APPENDIX C9
COMMENTS AND RESPONSES REPORT

PHAKWE RICHARDS BAY GAS-TO-POWER 3 2000MW COMBINED CYCLE POWER PLANT, KWAZULU NATAL PROVINCE
DFFE Ref. No.: 14/12/16/3/3/2/2117
COMMENTS AND RESPONSES REPORT

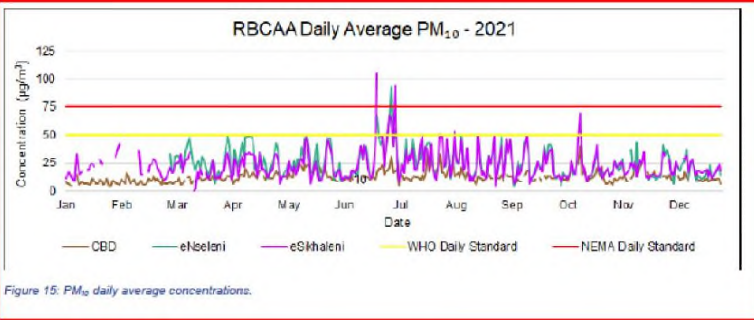
NO	COMMENT	RAISED BY	RESPONSE
	<p>gas capacity in deregulated grid areas will fail to recoup their initial investment.⁹⁹ The Climate Tracker project finance modeling yields a clear recommendation for both Europe and the United States: "constructing new gas plants is ill-advised and will result in projects that are unlikely to provide returns on investment in most countries." If these global North trends are replicated in South Africa, prospective gas generators and associated infrastructure may become stranded before reaching a break-even position. Due to the considerable period it takes for these types of developments to be developed and operational, the state will incur more losses as a result of stranding occurring considerably earlier in project time. This again warrants the consideration of whether the project is needed and desirable. It is argued that it is not so.</p>		<p><i>The development of the Phakwe Richards Bay Gas Power 3 CCPP is identified as a mechanism for securing additional power generation capacity as part of the Gas IPP programme. Furthermore, gas-fired and combined cycle power plants may also be regarded as a key technology to improve power production to meet demand, and for decarbonisation, as it reduces the carbon footprint of electricity compared with coal and oil-fired power plants. It may also complement the implementation of renewable energy sources, as it balances power supply from renewable sources and stabilises electricity grids.¹⁰¹</i></p> <p><i>Arguments that pause should be placed on any gas-to-power development until at least 2030 are noted, given the analysis that gas supply to balance higher penetration levels of variable renewable electricity will be unnecessary until 2035 (IISD, 2022), and that there is a move away from gas to the use of green hydrogen. As stated previously, it is the intention of the developer to use of natural gas (liquid or gas forms), or a mixture of Natural gas and Hydrogen (in a proportion scaling up from 20% H2) as fuel source. Recently green hydrogen, produced with renewable sources such as wind and solar energy, is getting a more prominent place in global policy thinking to limit global warming in the context of the Paris agreement. This has been accelerated in the wake of current global political and economic policies not achieving the agreed climate targets. At present, industry is already using large quantities of hydrogen, but this mainly produced from natural gas. Replacement with green hydrogen and expansion to more end-user segments contributes significantly to the (deep) decarbonisation of otherwise hard-to-decarbonise markets.</i></p> <p><i>South Africa is well-positioned to become a major player of green hydrogen in the world. The country has abundant land available and in combination with excellent potential solar and wind resources this could provide a solid base to produce one of the lowest cost green hydrogen in the world. South Africa's</i></p>
